MEMORANDUM

SUBJECT: **BZA Case 18654** – Expedited review requested pursuant to § 3118 for special exception relief in accordance with § 223 for deck additions to a two-story flat at 4008 3rd Street NW

Figure 2

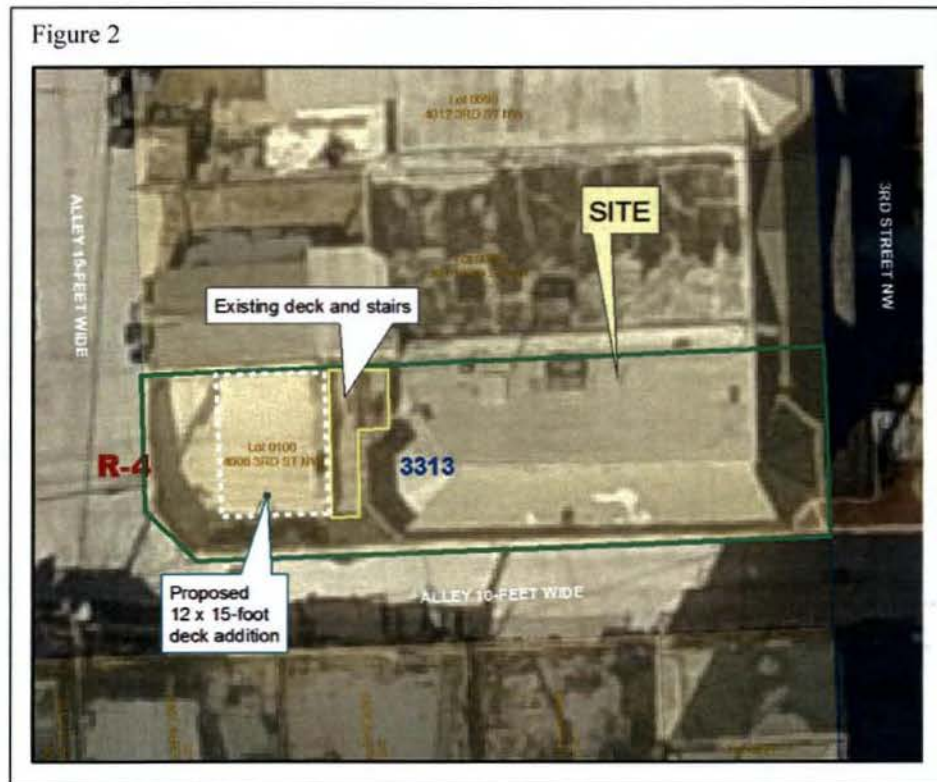
parking pad in the rear yard is surrounded by a gated fence with direct access to the alley (refer to Figure 2) According to zoning computation attached to this self-certified application, the current lot occupancy is 66% which exceeds the maximum 60% allowed in the R-4 District on lots developed with row dwellings and flats
Zoning	R-4 – allows flats and row dwellings as a matter of right
Historic District	None
Adjacent Properties	Predominantly two-story row dwellings of similar construction
Surrounding Neighborhood Character	Moderate-scale residential (refer to Figure 2)

OP estimated, based on the submitted plans, that the 12 x 15-foot deck addition would increase the current 66% lot occupancy to 72%³. This would exceed the maximum 70% allowed under this provision. The applicant

has not provided an explanation of how the proposed deck would meet the variance tests. OP could support a slightly *smaller* deck addition that would be consistent with the 70% maximum allowed by special exception.

Based on this analysis, the application meets the standards for special exception approval. However, to ensure the current onsite parking pad continue to be serviceable, OP suggests a condition of approval requiring the retention of existing rear yard parking pad with a minimum vertical clearance from the pad of 6-feet 6-inches to additional deck above in accordance with § 2115.5
